UNITED STATES PATENT AND TRADEMARK OFFICE

APPLICATION NO.	FILING DATE	FIRST NAMED INVENTOR	ATTORNEY DOCKET NO.	CONFIRMATION NO.
10/713,641	11/13/2003	Kevin J. Cummings	EH-11005 (03-539)	1649
34704	7590	04/07/2005	EXAMINER	
BACHMAN & LAPOINTE, P.C. 900 CHAPEL STREET SUITE 1201 NEW HAVEN, CT 06510			VERDIER, CHRISTOPHER M	
			ART UNIT	PAPER NUMBER
			3745

Office Action Summary	Application No. 10/713,641	Applicant(s) CUMMINGS ET AL	
	Examiner Christopher Verdier	Art Unit 3745

FIG. 2

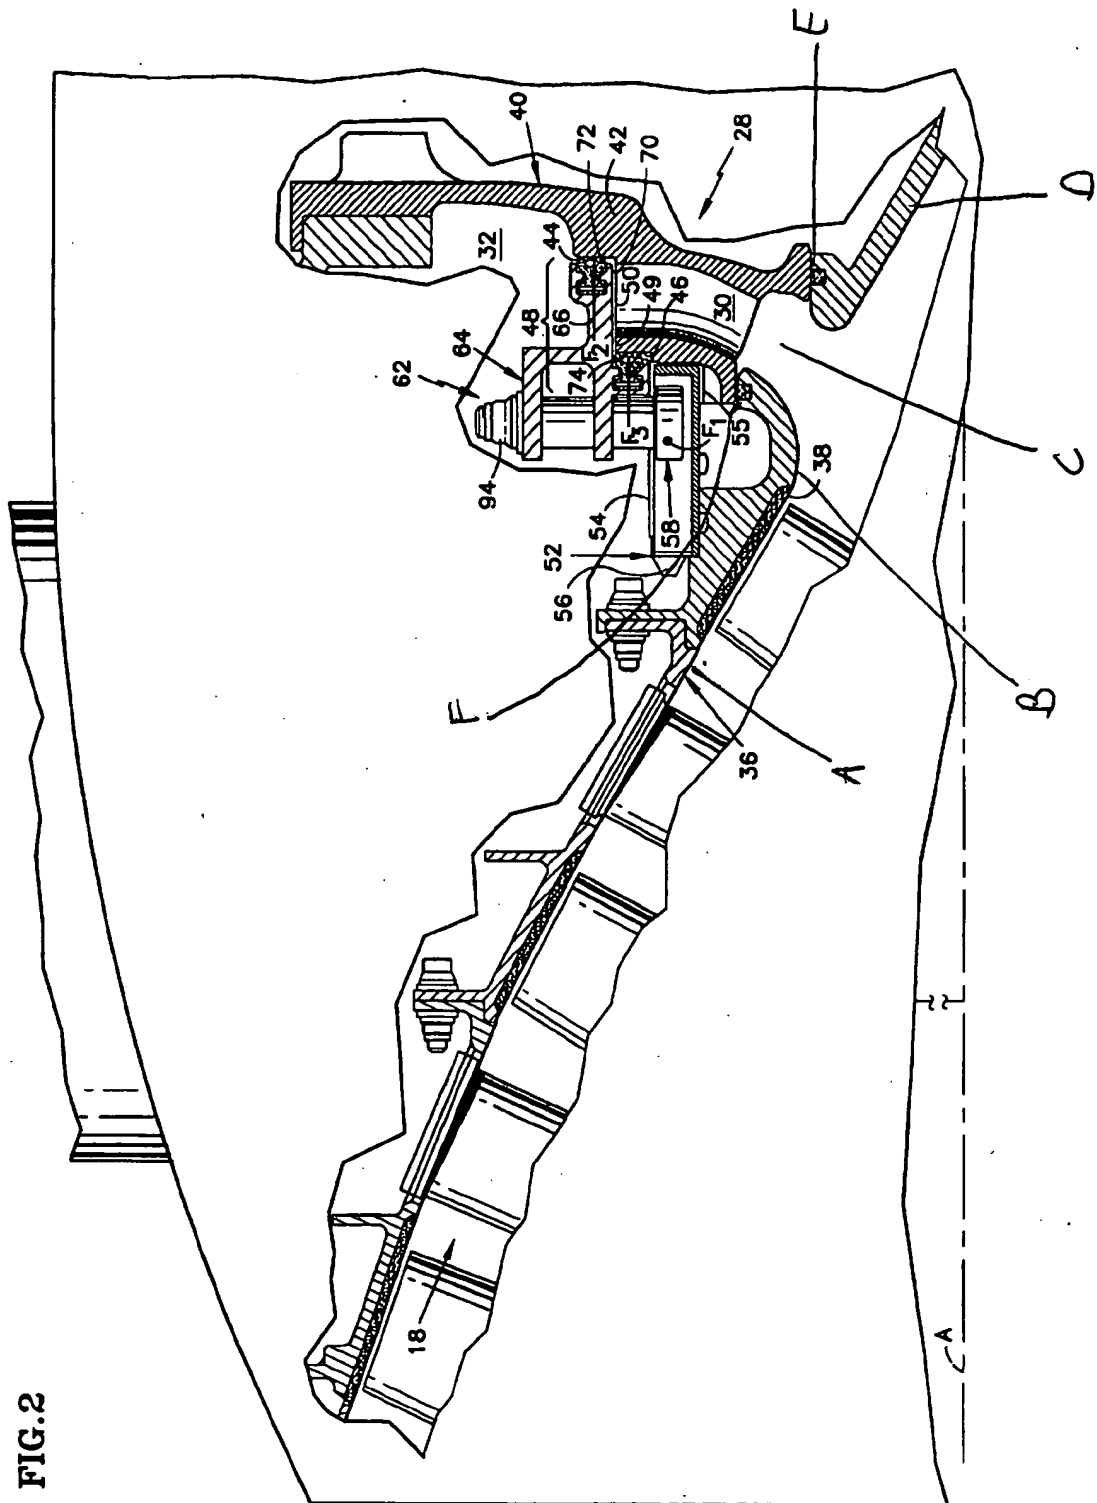
Claims 1, 5-6, and 9 are rejected under 35 U.S.C. 102(b) as being anticipated by Honda 6,092,987. Honda (please refer to the enlargement of figure 2 at the end of this action) discloses a gas turbine engine comprising a fan 22, a compressor 24 along a core flow path 18 and having a plurality of rows of unnumbered blades in figure 2, a plurality of rows of unnumbered vanes in figure 2, and a plurality of shroud rings A, B, a bleed one B of which defines a plurality of bleed ports C, a structural hub D downstream of the shroud rings and secured relative to the shroud rings (Note that the structural hub D is inherently secured to some portion of the engine, because high pressure working fluid passes through the core flow path and structural case 28 rests on and moves about the structural hub, therefore the structural hub D must be secured to some portion of the engine to prevent downstream movement of the structural hub. Note also that the phrase "secured relative to the shroud rings" does not require that the structural hub D is secured to the shroud rings, but only that it is secured relative to the shroud rings.), a structural case 40/42 extending from an aft joint E with the structural hub to a fore joint F with a joined one of the shroud rings B and having a plurality of valve ports 30, at least a portion of the structural case extending structurally between the fore and aft joints, and a valve element 62 shiftable between a first condition in which the valve element blocks communication through the valve ports, and a second condition in which the valve element does not block the communication. The valve element is shiftable via combined circumferential rotation and longitudinal translation. The valve element carries an outboard aft seal 72 and an inboard fore seal 74 for sealing with the structural case in the first condition. At least a portion of the structural case (the inner

FIG. 2

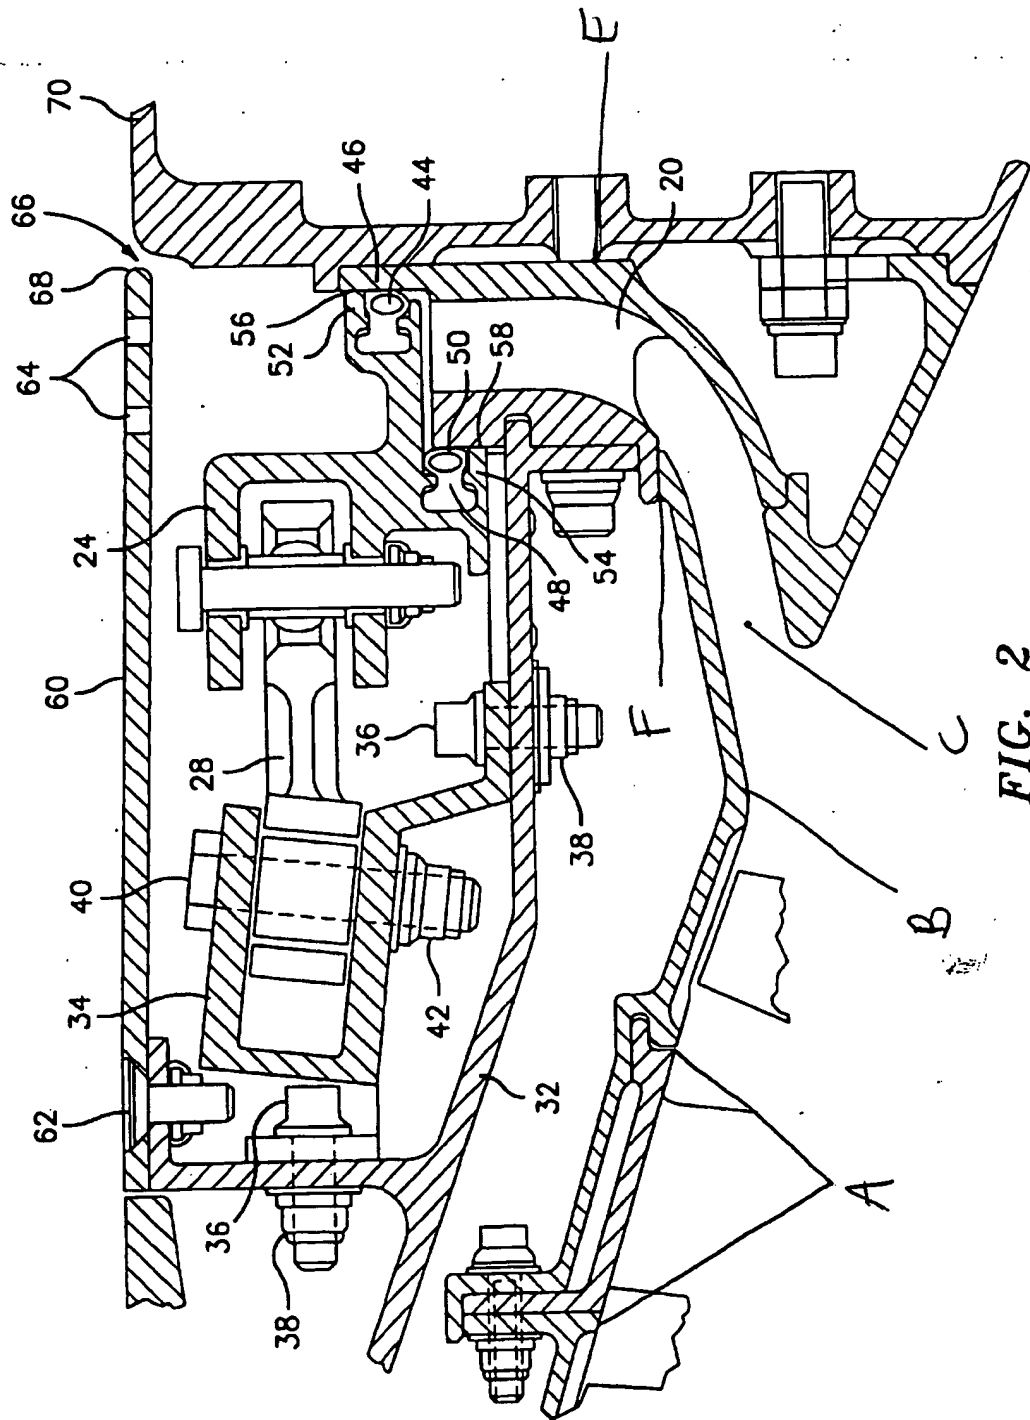
Claims 1, 5-6, and 9 are also rejected under 35 U.S.C. 103(a) as being unpatentable over Chlus 6,802,691 in view of Honda 6,092,987. Chlus (please refer to the enlargement of figure 2 at the end of this action) discloses a gas turbine engine comprising a fan 12, a compressor 14 along a core flow path 16 and having a plurality of rows of unnumbered blades in figure 1, a plurality of rows of unnumbered vanes in figure 1, and a plurality of shroud rings A, B, a bleed

one B of which defines a bleed port C, a structural hub 70 downstream of the shroud rings and secured relative to the shroud rings (Note that the structural hub 70 is inherently secured to some portion of the engine, because high pressure working fluid passes through the core flow path and the structural case shown generally at 20 rests on and moves about the structural hub, therefore the structural hub 70 must be secured to some portion of the engine to prevent downstream movement of the structural hub. Note also that the phrase "secured relative to the shroud rings" does not require that the structural hub 70 is secured to the shroud rings, but only that it is secured relative to the shroud rings.), a structural case shown generally at 20 extending from an aft joint E with the structural hub to a fore joint F with a joined one of the shroud rings B and having a valve port 20, at least a portion of the structural case extending structurally between the fore and aft joints, and a valve element 24 shiftable between a first condition in which the valve element blocks communication through the valve port, and a second condition in which the valve element does not block the communication. The valve element is shiftable via combined circumferential rotation and longitudinal translation (note that the term "is shiftable" is a recitation of intended use. A recitation of the intended use of the claimed invention must result in a structural difference between the claimed invention and the prior art in order to patentably distinguish the claimed invention from the prior art. If the prior art structure is capable of performing the intended use, then it meets the claim. In a claim drawn to a process of making, the intended use must result in a manipulative difference as compared to the prior art. See *In re Casey*, 370 F.2d 576, 152 USPQ 235 (CCPA 1967) and *In re Otto*, 312 F.2d 937, 939, 136 USPQ 458, 459 (CCPA 1963)). The valve element carries an outboard aft seal 44 and an inboard fore seal 48 for sealing with the structural case in the first condition. At least a portion

However, Chlus does not disclose that the bleed port C is plural bleed ports, and does not disclose that the valve port 20 is plural valve ports.
